RE: M/48/26/HH- Request for additional information.

1 attachment (255 KB)
Proposed North and South.pdf;

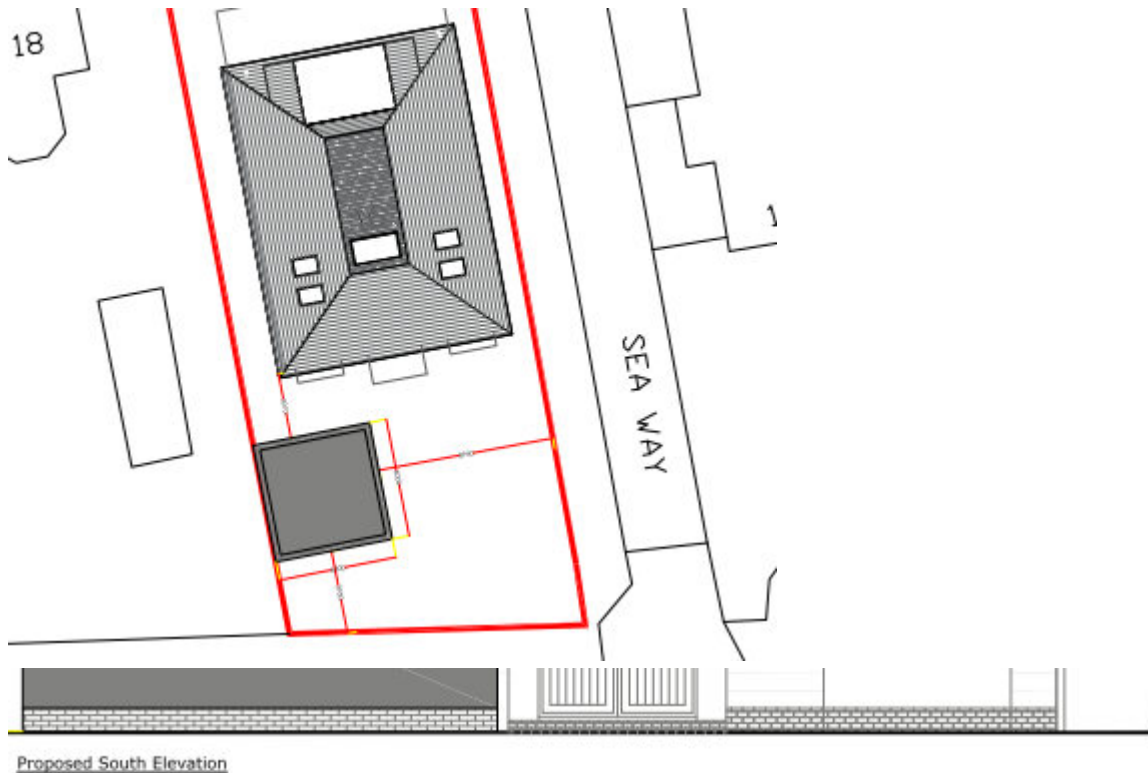
Below are some photos to show the inconsistencies I have mentioned: The plans for the application need to be consistent with the plans throughout any statement that you provide, as you can see the North elevations of the roof are inconsistent here.

The Proposed north elevation plan rooflights are still inconsistent with the plans visible in the Flood risk assessment and surface water drainage safety statement.

Once this is fixed and the fee comes through on our system, we will be able to validate this for you.
